Product Change Notification

Type of Notification: Changing Zener diode (ZD701)

LDC60F-□

Fig.2.1 Photograph of "Existing" and "Changed"

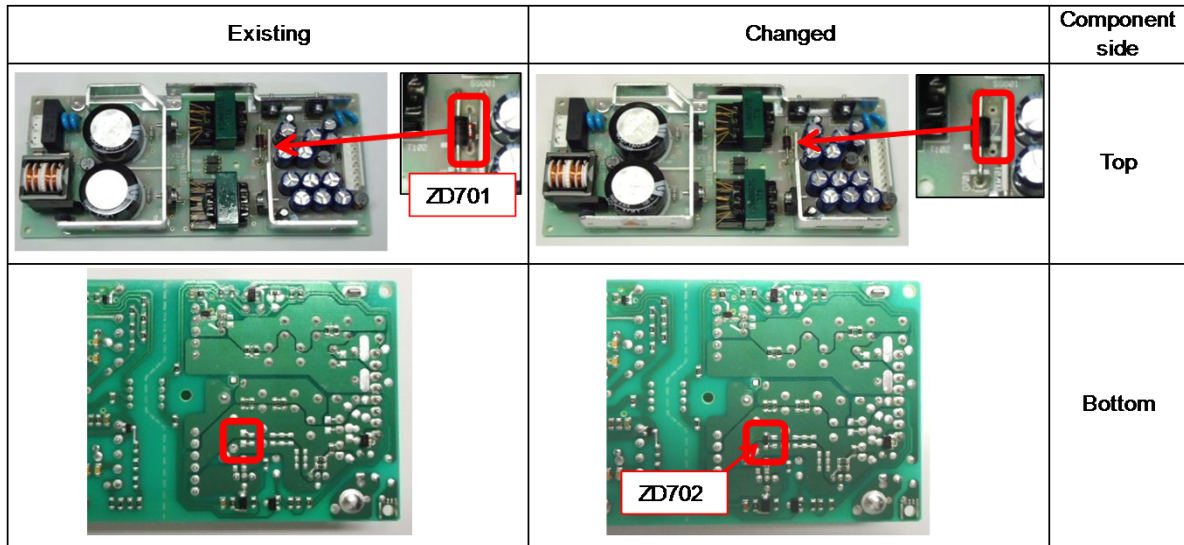
Following component is reaching the end of production life, and an equivalent component will be replacing it (See table below).

No.	Change parts	Contents	Existing	Changed
1	Zener diode	Parts number	ZD701	ZD702
		Manufacturer	Panasonic	Panasonic
		Type name	MAZ2360	DZ2W360
		Package	Axial	SMD
		Zener voltage	36V	36V
		Power dissipation	1W	1W
		Junction temperature	200°C	150°C

This change does not affect electronic or mechanical specifications, nor does it affect safety compliance.
